**SAFETY
RECALL**

SR17-11A

DATE :	June 2017	SECTION :	23 ACCESSORIES
SUBJECT:	TRAILER HITCH RECEIVER HARDWARE REPLACEMENT

REVISION A: THIS SAFETY RECALL SUPERSEDES PREVIOUS VERSION.
 2017-06-22 MATERIAL: Washer is 500011, was 500211. Kit was SR17-11, is SR17-11A

Figure 3: Hardware Removal

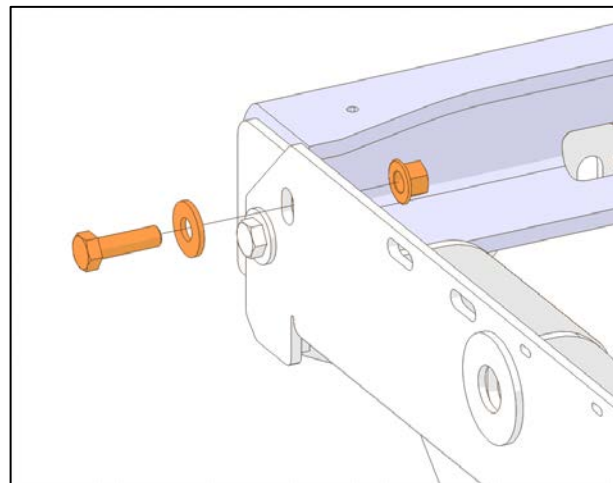
4. One at a time, remove nuts, bolts and washers holding the receiver. (Figure 3)
5. Discard removed hardware.

Figure 4 : New hardware

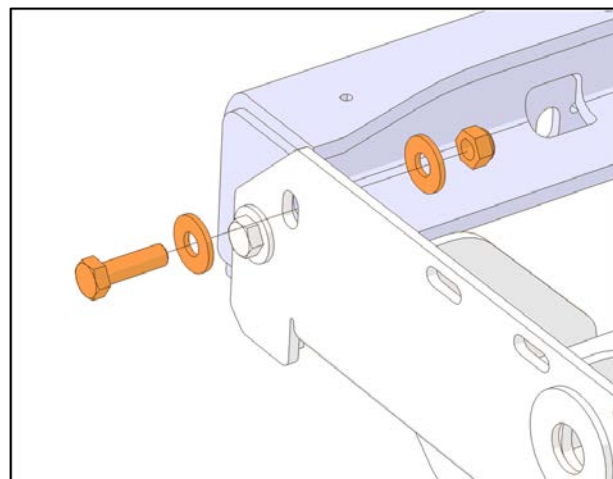
6. Replace by new hardware.
Tighten to **82 lb-ft**.

Figure 5: "Torque Seal" Anti-Tamper Marking

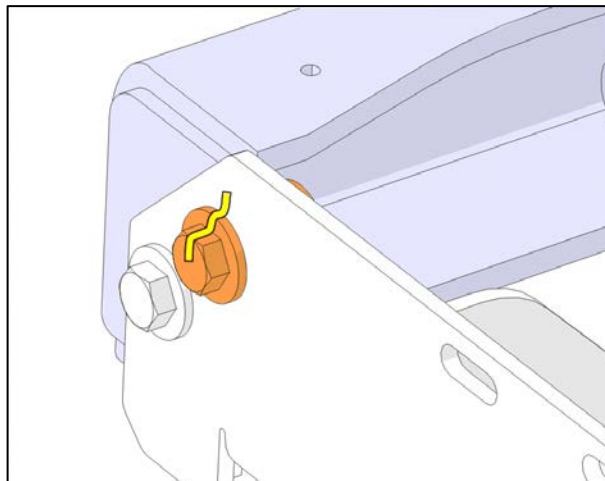
7. Apply torque seal mark across bolt head, washer and frame.
